Environmental Implications of Change Report

LLK1-ARU-XXX-XXX-RP-ENV-000003

Issue 1

lionlink!

Inset 4.1 Assessment locations for the G3 proposed Landfall Site

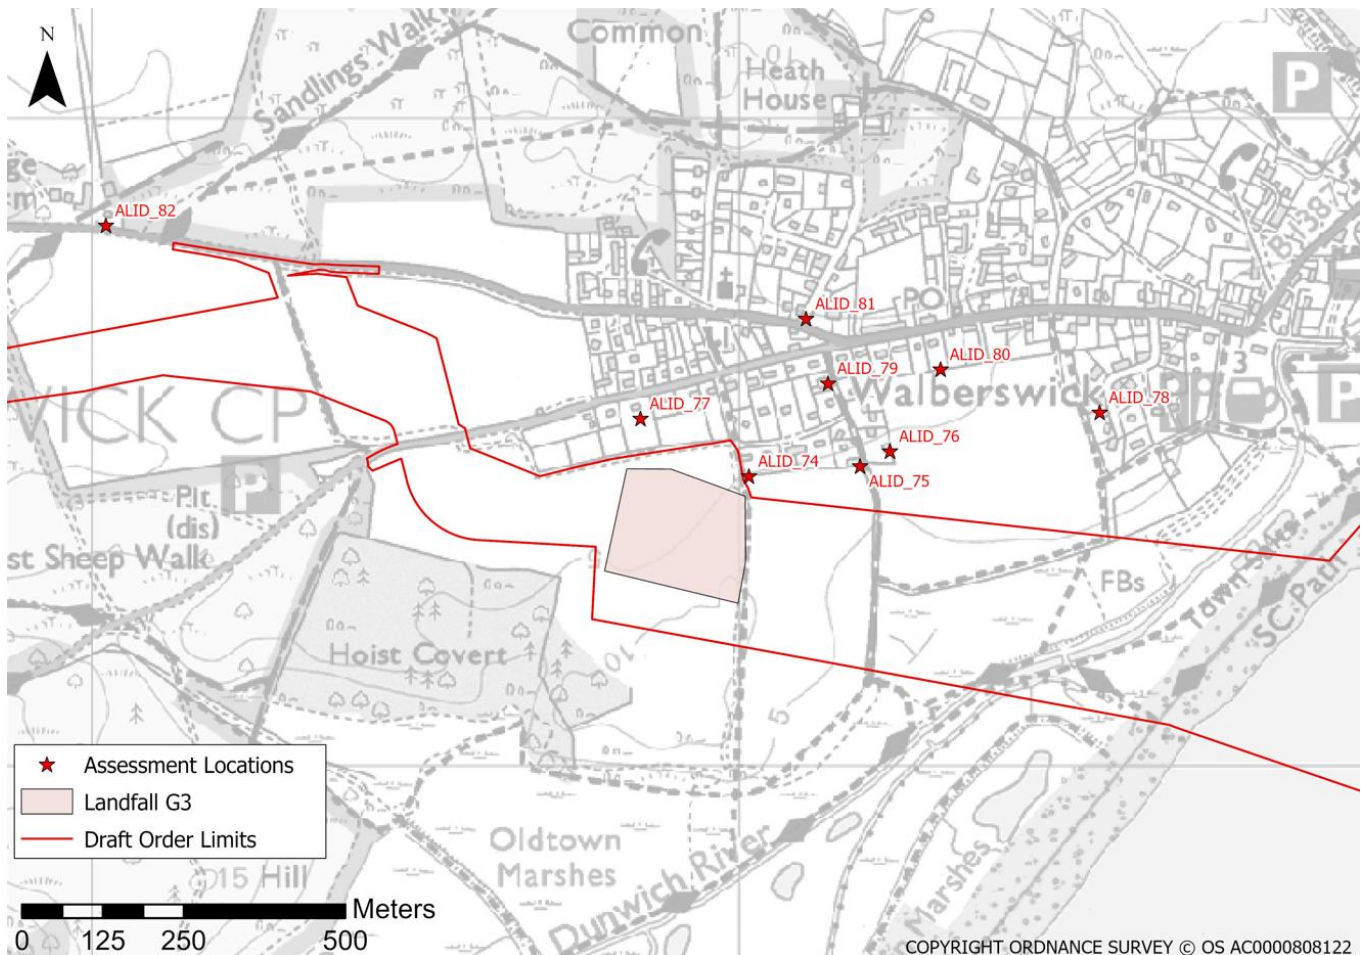
4.11.3 The proposed relocation of the proposed Landfall Site has the potential to have a greater impact on the receptors located to the south of Seven Acres Lane, south of Walberswick. These receptors are represented by ALID_77 and ALID_74.

A.2 Localised changes at proposed Landfall

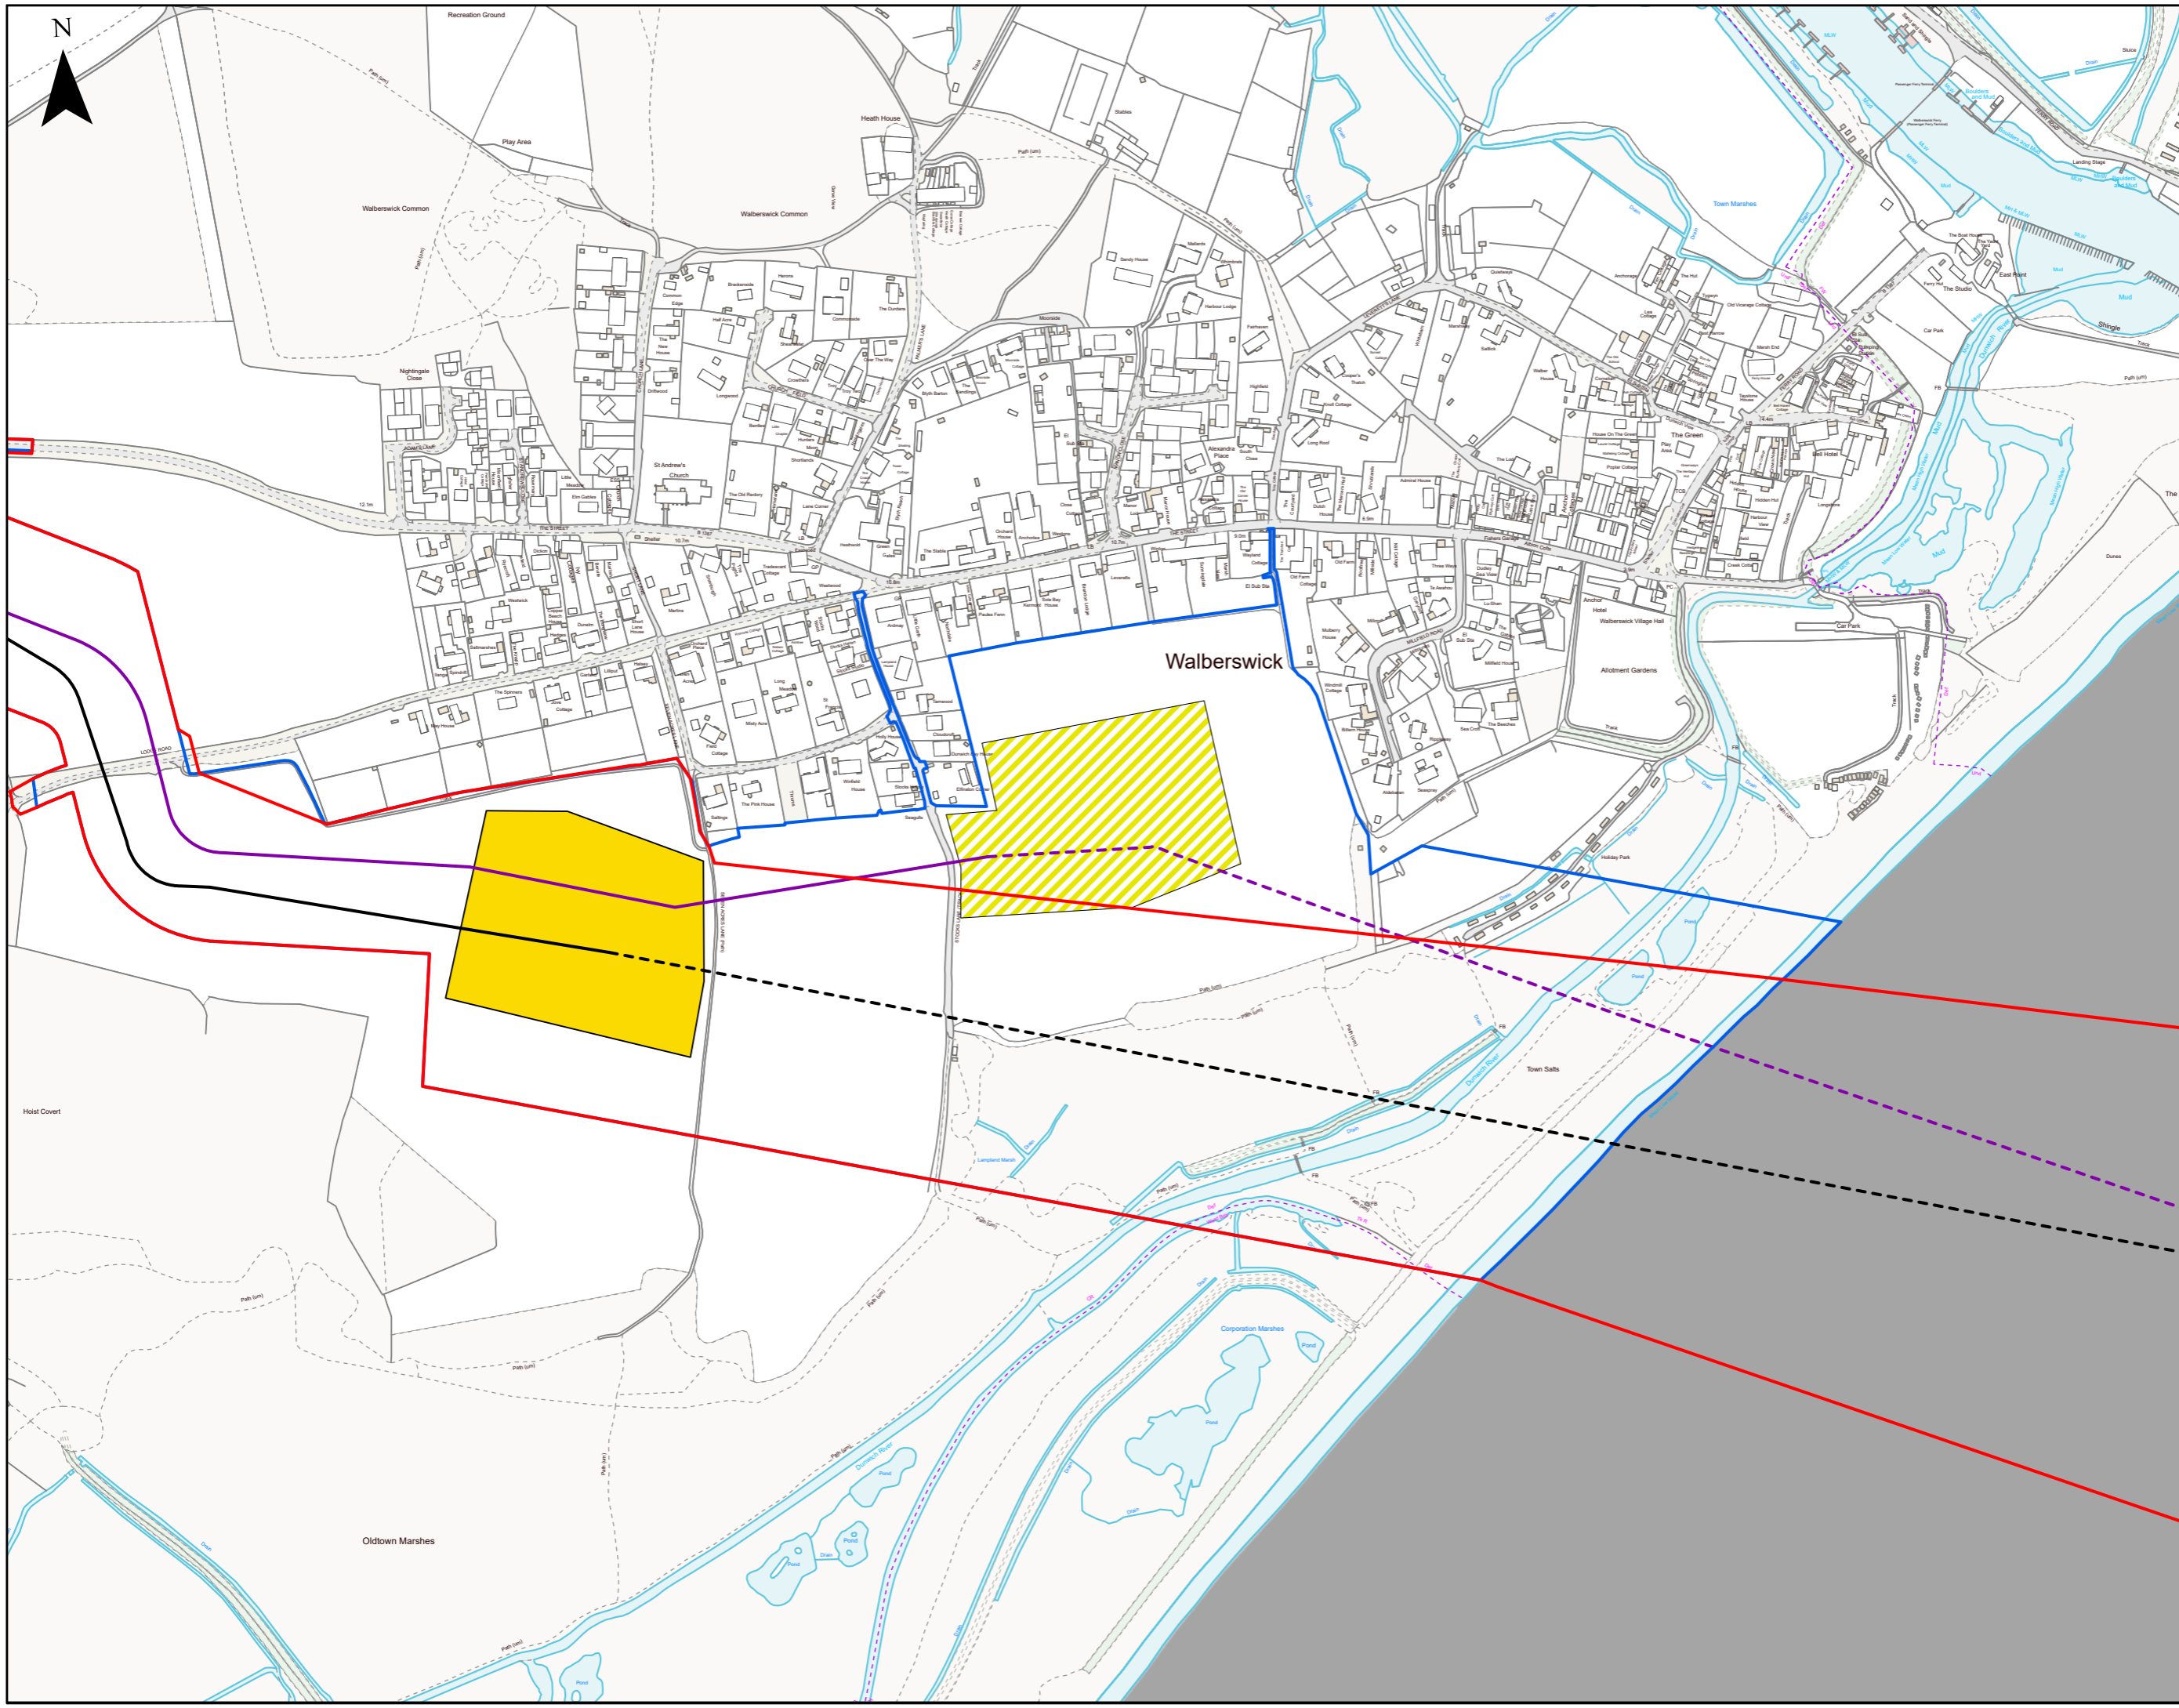
2.2.2 An alternative Proposed Landfall Site at Walberswick has been identified following consideration of consultation feedback and ongoing environmental, technical and planning assessments. This location, referred to as G3, is approximately 450 metres (m) west of the previously identified G2 site and is positioned further from the main village of Walberswick shown in **Appendix A: Figures**.

2.2.3 This design change to G3 would mean no construction works are proposed within Manor Field, and would remove the potential use of Stocks Lane, and certain footpaths, for utilities connections to the B1387 (Lodge Road/The Street). Construction access would continue to be via a temporary haul road from the B1387 as described in the **2026 PEIR**. Therefore, this proposed change to the Landfall Site provides a rationalisation of the DOL to reflect the revised design and reduce the extent of land required.

- 2.2.5 The revised location of the proposed Landfall Site considered potential impacts to local communities, landscape character and environmental receptors, amongst other factors. Environmental assessments indicate greater separation to sensitive receptors compared with the previously identified site. Trenchless installation beneath the beach would avoid surface excavation at the landfall, consistent with the approach presented in the **2026 PEIR**.
- 2.2.6 Construction at the proposed Landfall Site is anticipated to take approximately 20 months, including site establishment, drilling, cable installation and reinstatement. Some activities would need to be undertaken continuously where it is not practicable to pause operations. This approach to construction remains as it was presented during our Statutory Consultation.

A.3 Localised changes at Benhall Railway Bridge

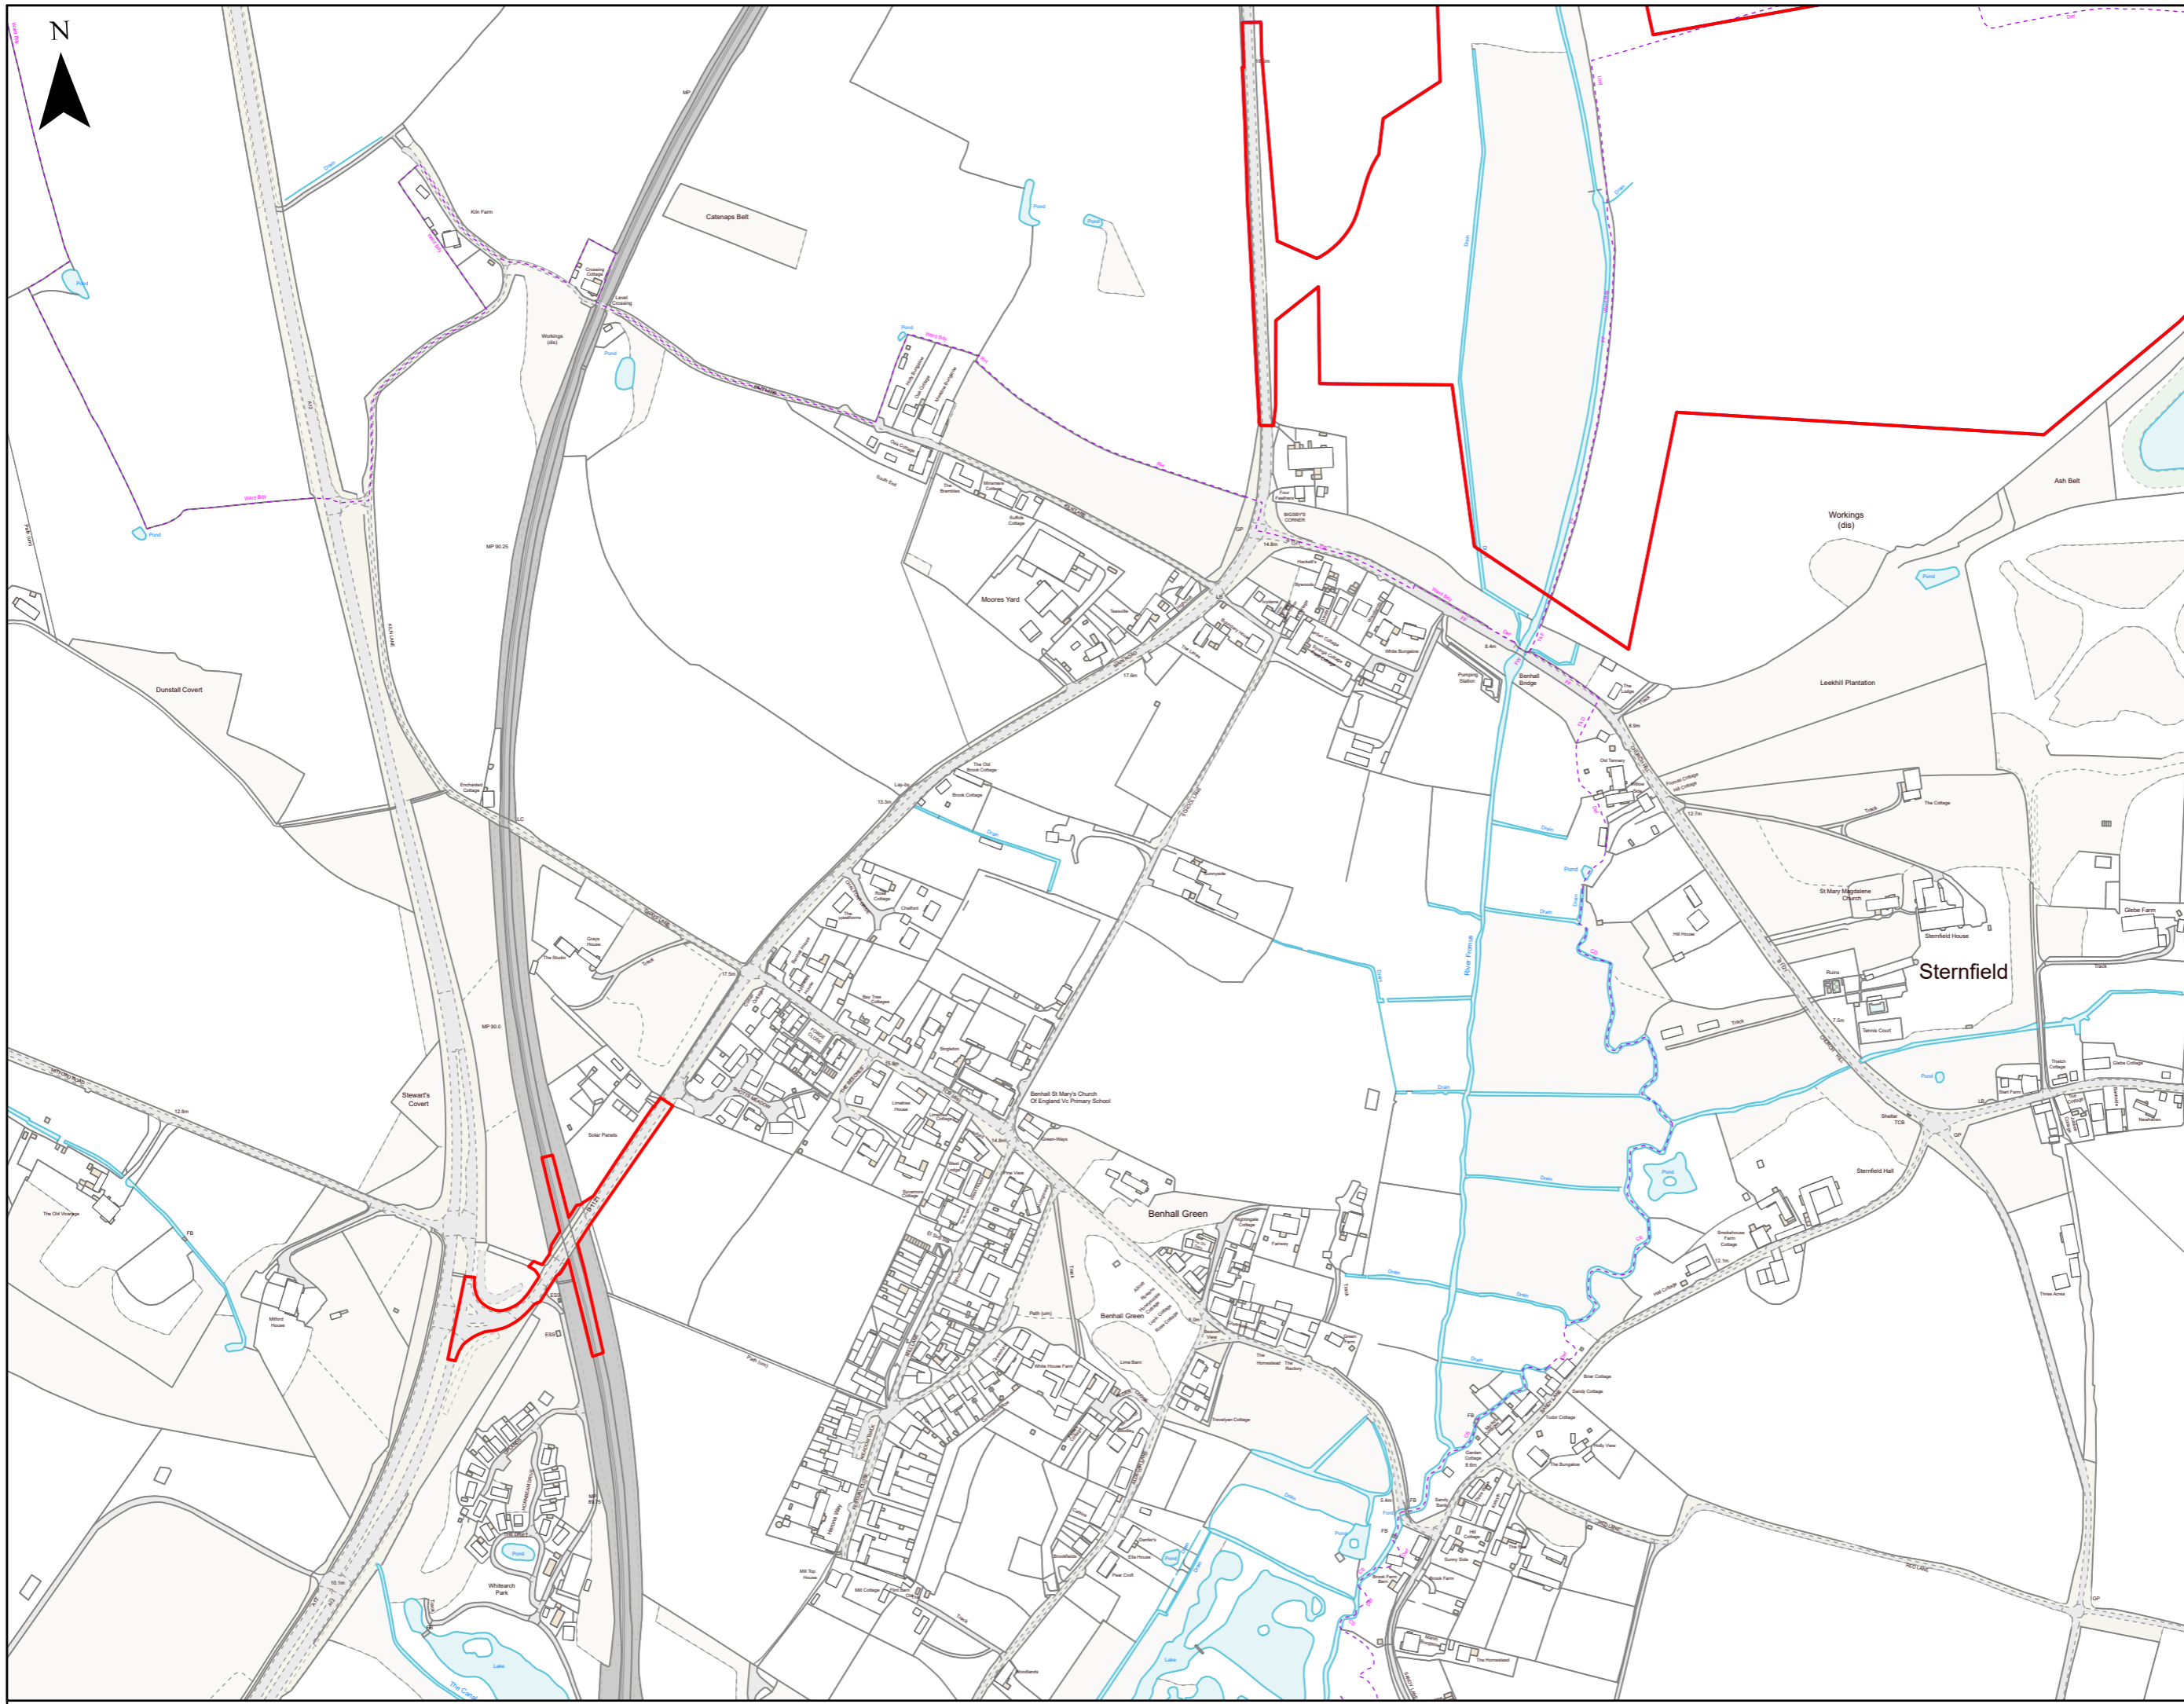
- 2.6.2 The B1121 is one of the main construction routes to the Proposed Scheme. The Benhall Railway Bridge is located on the B1121, crossing the East Suffolk Line, southwest of the village of Benhall. The Benhall Railway Bridge is currently restricted by a 46-tonne weight limit which would constrain construction vehicle movements. The proposed design change is to include the Benhall Railway Bridge into the DOL.

- 2.6.10 The works would be temporary in nature, with no permanent modification to the existing bridge. Following completion of the relevant construction activities, the structure would be removed and the bridge surface reinstated to its existing condition.
